Public Input No. 124-NFPA 54-2024 [Global Input]

NFPA® 54

National Fuel Gas Code

Reference: Various paragraphs throughout
TIA 24-1
(SC 23-8-51 / TIA Log #1726)

Figure 9.6.8-2 Method of Installing a Tee Fitting Sediment Trap.

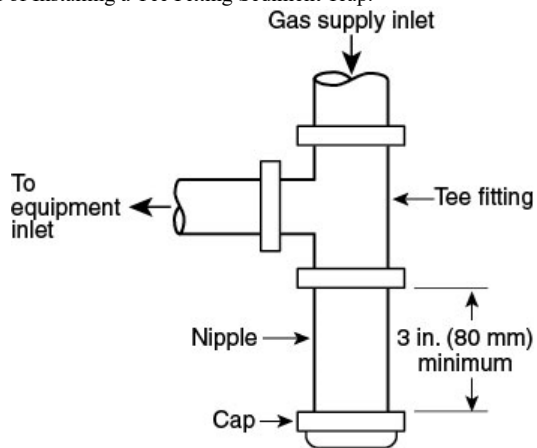
The sediment trap shall be either a tee fitting with a capped nipple in the bottom outlet, as illustrated in Figure 9.6.8-2, or another device recognized as an effective sediment trap.

Figure 10.25.2.25 Installation of Type B-W Gas Vents for Vented Wall Furnaces.

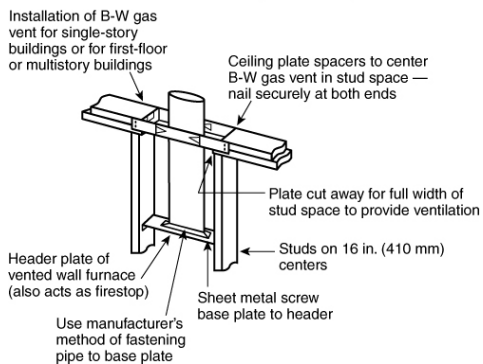
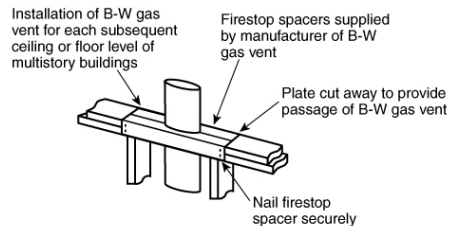
Type B-W gas vents shall be ~~both~~ attached directly to a solid header plate that serves as a firestop at that point and that shall be permitted to be an integral part of the vented wall furnace, as illustrated in Figure 10.25.2.25.

Figure 9.6.8 Method of Installing a Tee Fitting Sediment Trap.

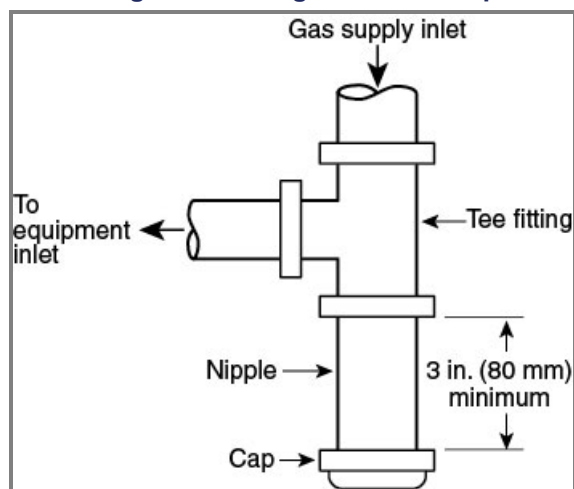
consisting of either a tee fitting with a capped nipple in the bottom outlet, as illustrated in Figure 9.6.8, or another device recognized as an effective sediment trap shall be installed

be so equipped

have a sediment trap.
